**CONSTRUCTION OF MUTIRITHIA WATER
SUPPLY AND SANITATION PROJECT**

NRW/05/2022-2023

Project: Construction of Mutirithia water supply and sanitation project

CLARIFICATION/ADDENDUM NO. 1

Drawing 1: not into scale

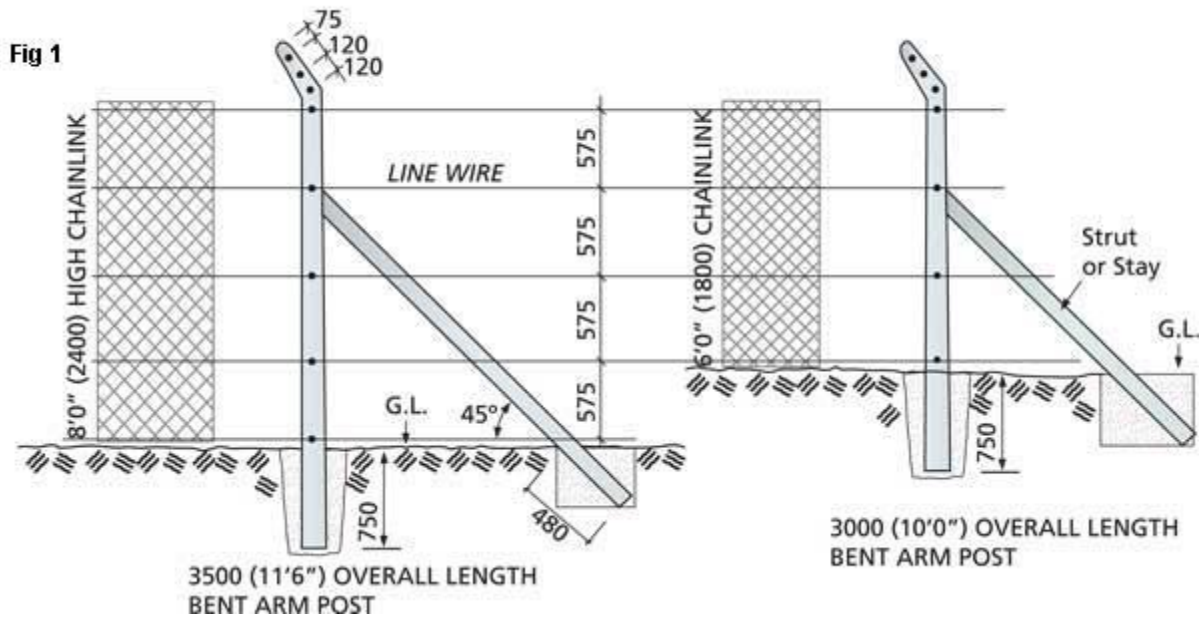
Question no. 4 (c): Kindly give the concrete post size and if possible, the drawings on the item (F) S/No. 4

The fencing posts conform to the Reference Standard: KS 1186: 2003 – Specification for reinforced concrete fencing posts and struts/concrete and concrete products, that ensures the product guarantee is

maintained with dimensions being 150x100x2400 (8ft). the base where the 14-gauge chain link 7ft long with touches the ground shall be well anchored to the ground.

Drawing 2: entry and exit gates illustration

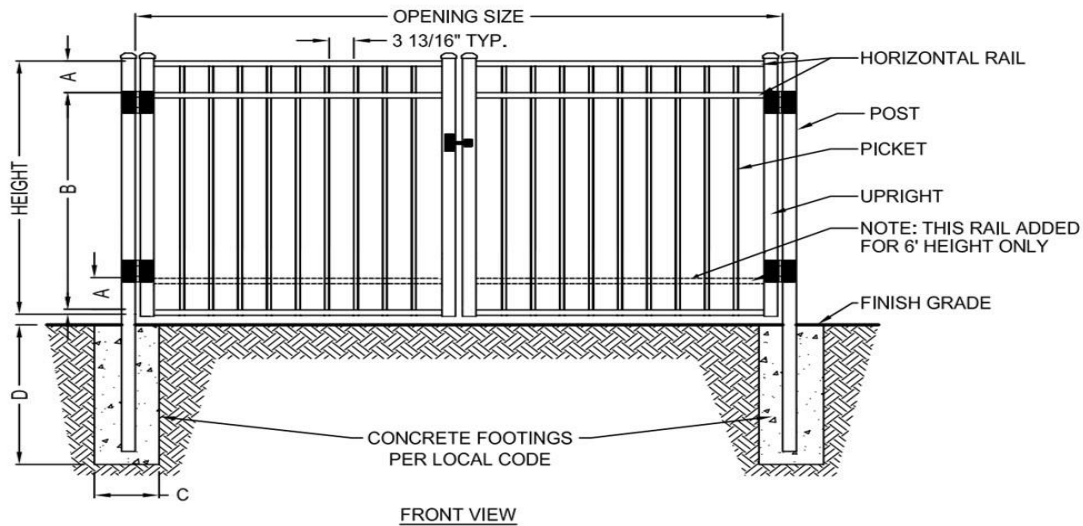
Question no. 4 (d): steel gate. Kindly give the gate size and drawing if possible

Please see attached illustration of the gate requirements. Please note we are looking forward to installation entry and exit gates due to inadequate spacing at the stabilization ponds site.
